## Resolution Concerning the Realignment of the ISTE A Trail in Colorado River Park

## PEDESTRIAN PLAN COMMENTS

Subject: Construction of Jeffries Boat dock at 3106 Rivercrest Drive  
File No. SP-99-0198DS.

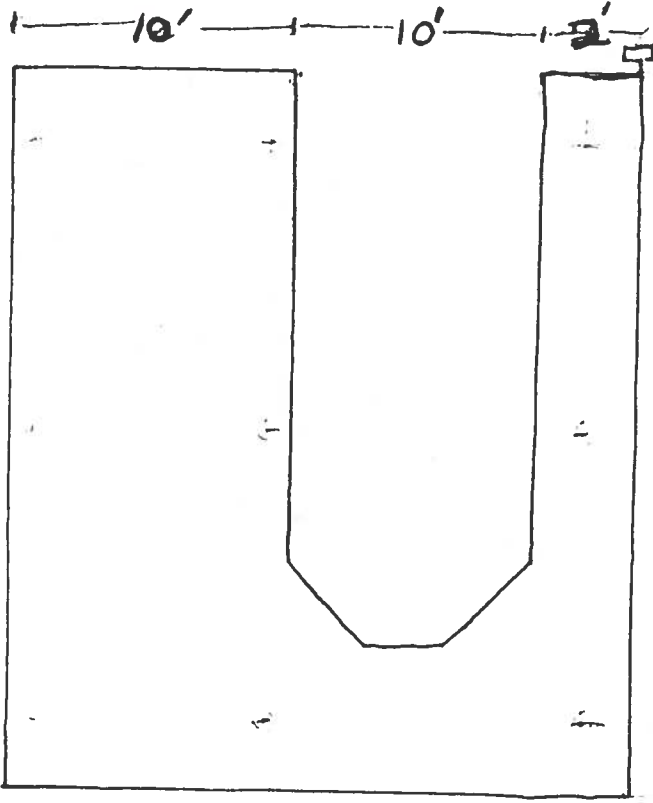
The Parks and Recreation Department (PARD) staff has reviewed plans for the proposed project and finds they meet all the requirements of Article XIII, Section 25-2-1176, (Regulations for the Construction of Boat Docks) of the Land Development Code.

I recommend approval of the above request as detailed in the attached site plan.

Subject: Construction of McWilliams Boat dock at 203 Lago Verde Dr.  
File No. SP-99-2196DS.

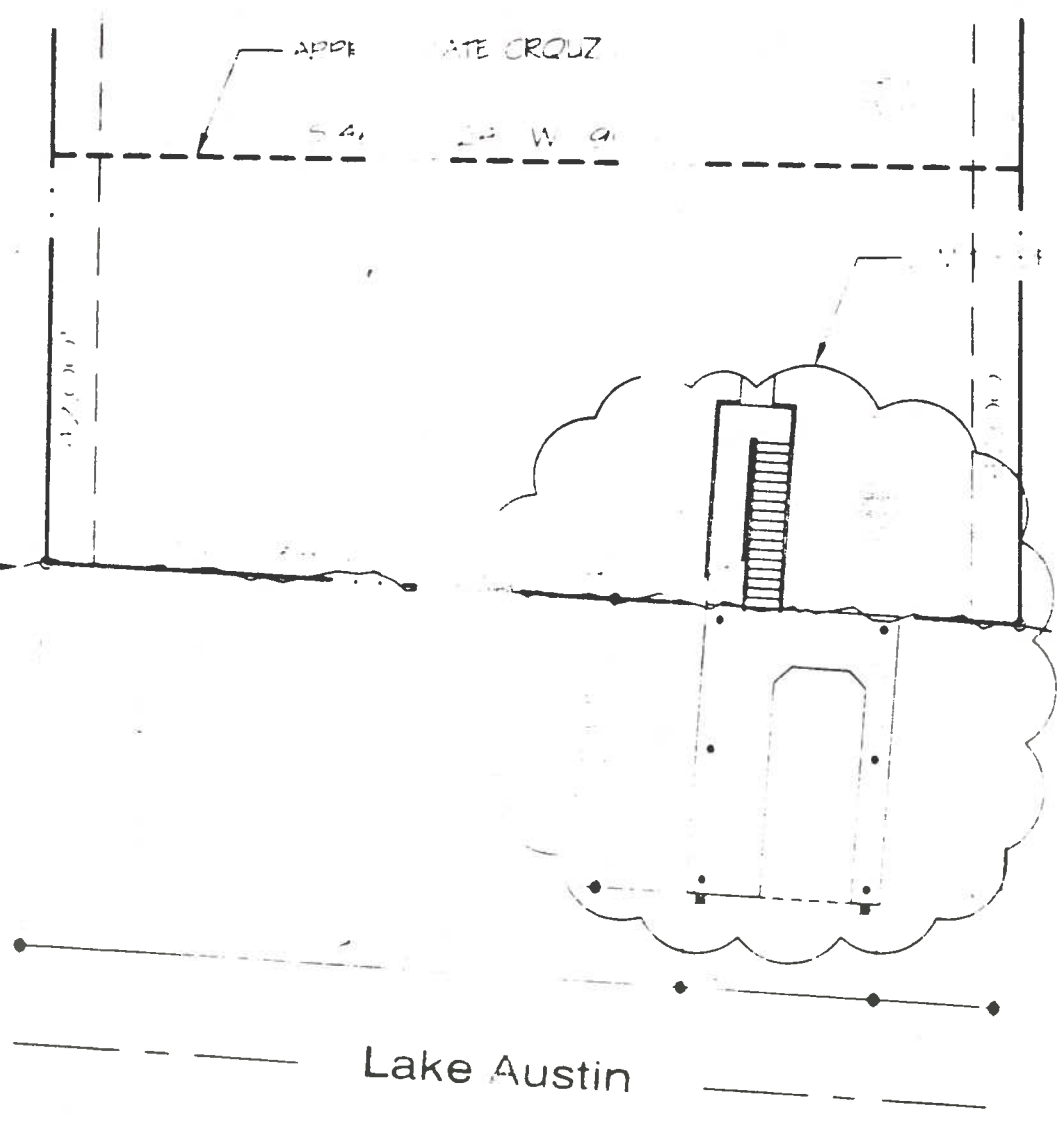
The Parks and Recreation Department (PARD) staff has reviewed plans for the proposed project and finds they meet the requirements of Article XIII, Section 25-2-1176, (Regulations for the Construction of Boat Docks) of the Land Development Code.

I recommend approval of the above request as detailed in the attached site plan.

Subject: Construction of Pizzitola Boat dock at 3113 Brass Buttons Trail  
File No. SP-99-2082DS.

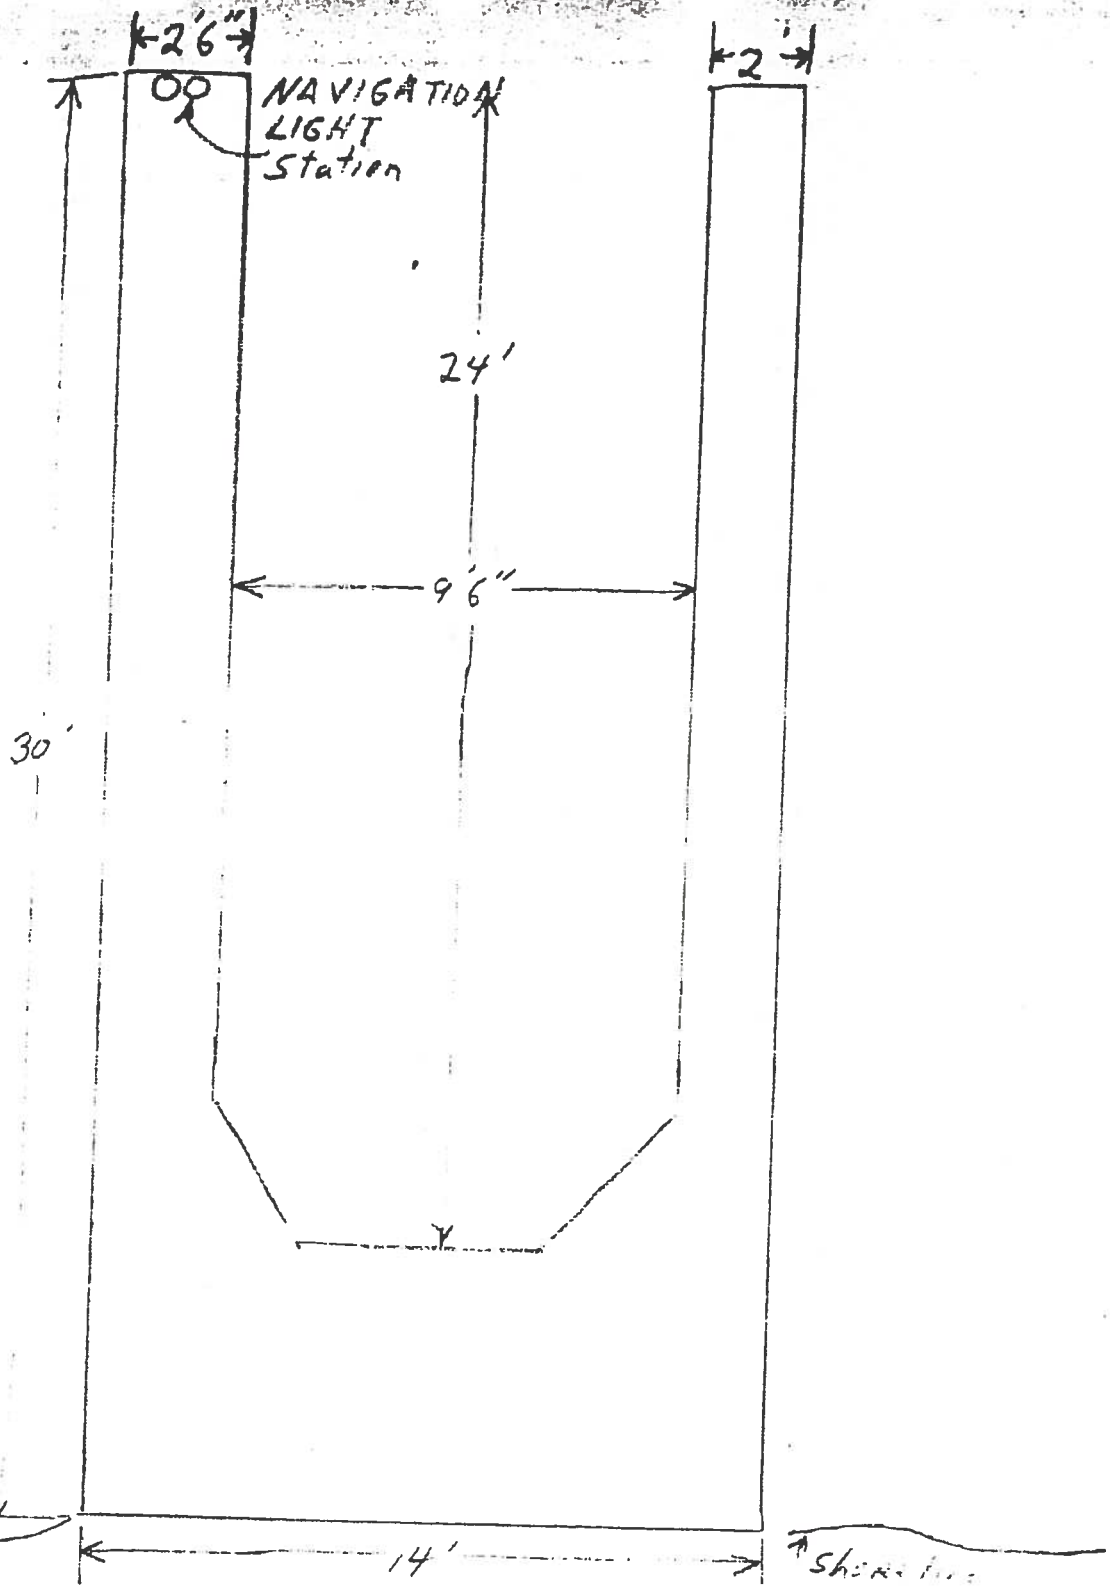
The Parks and Recreation Department (PARD) staff has reviewed plans for the proposed project and finds they meet the requirements of Article XIII, Section 25-2-1176, (Regulations for the Construction of Boat Docks) of the Land Development Code.

I recommend approval of the above request as detailed in the attached site plan.
